Re: Land Adjacent to Shell Garage, Worthing Road, Littlehampton - Planning Ref
LU/20/17/PL
- Planning Condition 4 - Surface Water Drainage

I write in response to Arun District Council's decision notice on application reference LU/253/17/DOC, dated 3rd November 2017. I note the requirement to provide full justification for discounting infiltration drainage methods and seek to address this below.

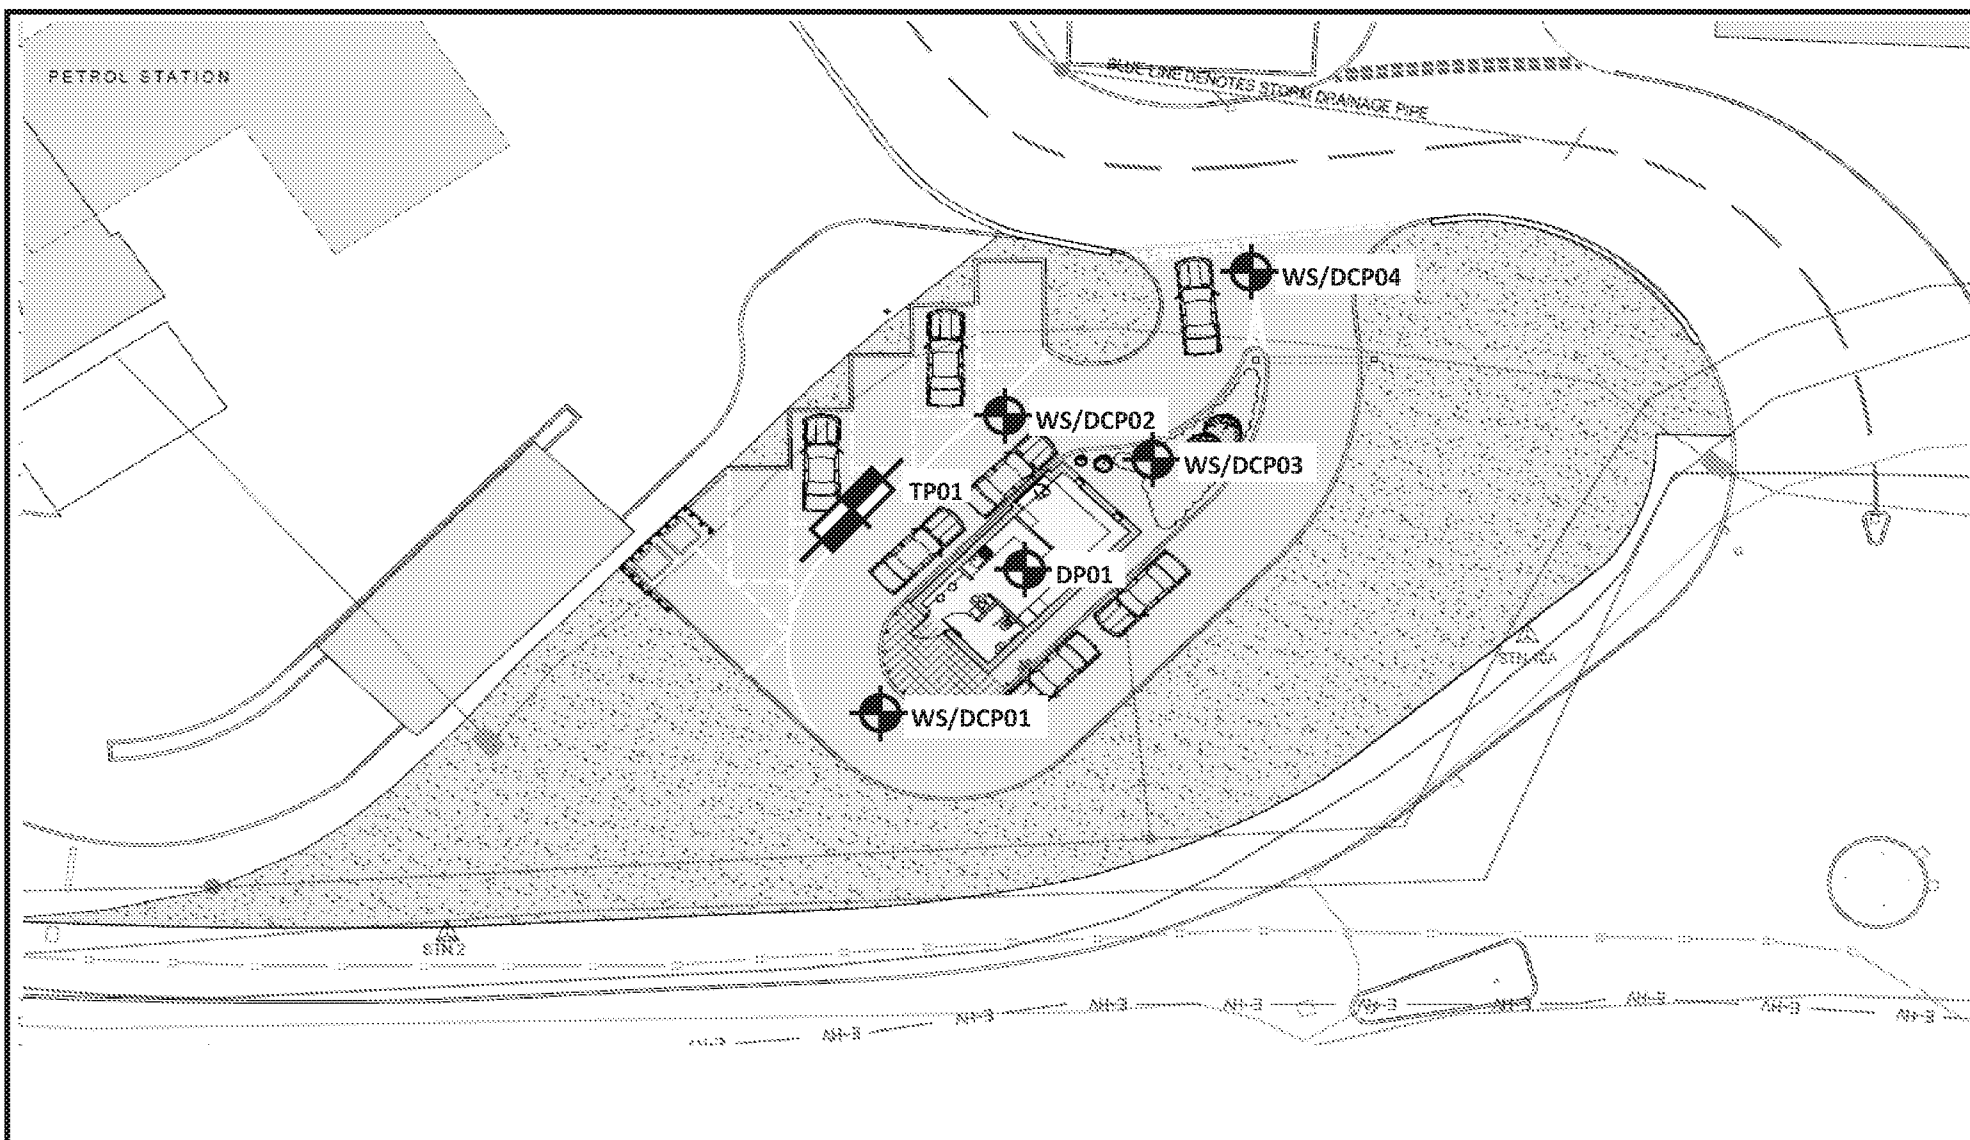
Intrusive Site Investigation was undertaken in May 2017. The works comprised a trial pit excavated to a depth of 3m and 4 No. boreholes to 4m depth. Beneath a shallow layer of topsoil/made ground, clay based River Terrace Deposits were encountered to a depth of 3-4m below ground level in 4 No. boreholes, and to 1.8m below ground in bore hole WS04 in the western part of the site, where chalk was encountered beneath the River Terrace Deposits to a depth of 4m below ground level. Refer to the attached bore hole logs and location plan.

While it is acknowledged that the infiltration test was not performed in the location of the proposed SUDS system, please note that the underlying strata do not vary significantly across the site; the only materials present are the River Terrace Deposits and the underlying chalk, as the attached borehole logs confirm.

As discussed above, the testing in WS01 established that the River Terrace Deposits, being predominantly clay based, are impermeable, and the SI report confirms that the chalk is not suitable for soakaway drainage. We therefore consider the location of the testing within what is a relatively small site area to be unimportant in this instance.
